2018 Panigale V4 Fuel Tank Updates - CR148 Recall Service Bulletin SRV-RCL-18-002 Panigale V4 (All Models and Country Versions)

Date: Thursday, March 29th, 2018

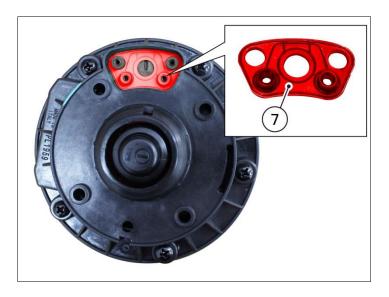
- 4) <u>Slightly lift, without removing, the valve unit (6)</u> using a small flat screwdriver in the grooves.
- 5) Turn the filler plug upside down and <u>carefully remove</u> the **valve unit (6)** without letting the internal components fall out.

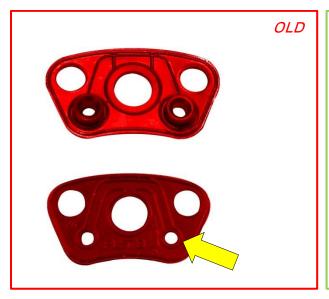
6) Remove the **seal (7)** from the filler plug.

7) Take the new seal **part no.86640151A** in Viton, which can be recognised both because of its material and because of the new breather channel on the rear side.

8) Install the new seal (A) in the relevant seat of the filler plug by orienting it as shown in the figure.

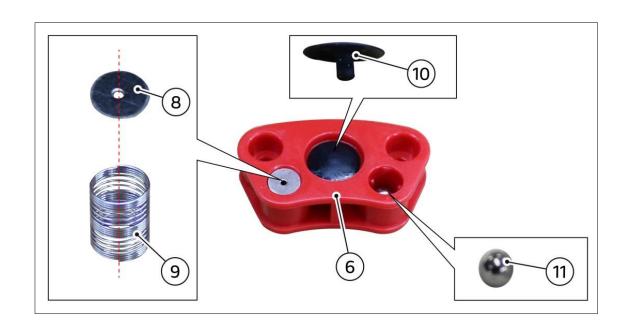
- 9) Remove all components inside the valve unit (6):
 - drilled washer (8);
 - spring **(9)**;
 - rubber retainer (10);
 - ball (11).

The only component among the removed ones that must be used again when refitting the valve unit is the ball (11).
